Jefferson County
Board of Commissioners
Agenda Request

Subject: Change Order #1, Ovivo USA, LLC
Port Hadlock Wastewater Project

CHANGE ORDER NO.: 1

ECN 7 for Increase WAS Pump to Port Hadlock

Specification Sheet (1/2)

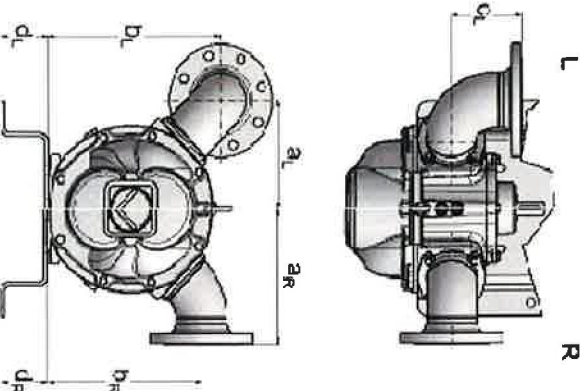
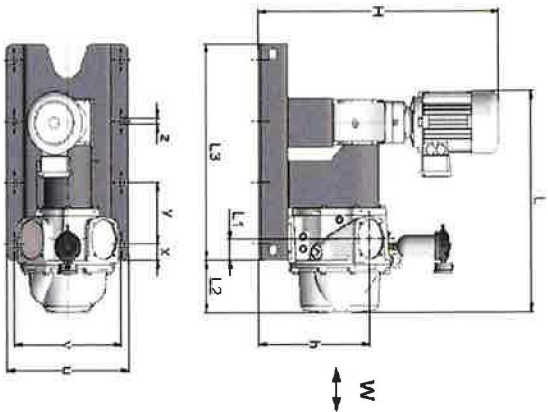
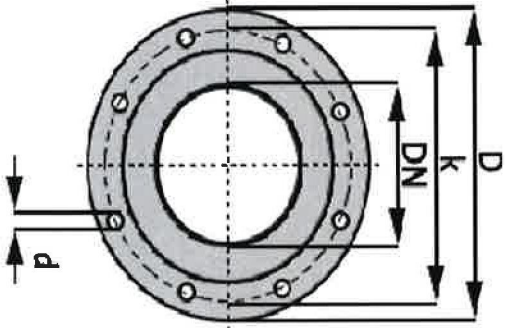
Client requests a larger WAS pump to support their sludge thickening / dewatering system.

Change Order covers material cost price differential between current pump and new larger pump size. Change Order covers labor cost to correctly size and specify new pump along with update Ovivo documentation to reflect new pump on drawings (P&ID, PFD, General Arrangements, Electrical Drawings, etc.) and to update documentation within submittal (Scope of Supply, Vendor Cutsheets, etc.)

- Ovivo to provide a new WAS pump, capable of 25-40gpm; fully installed and integrated on MicroBLOX skid in place of current WAS pump
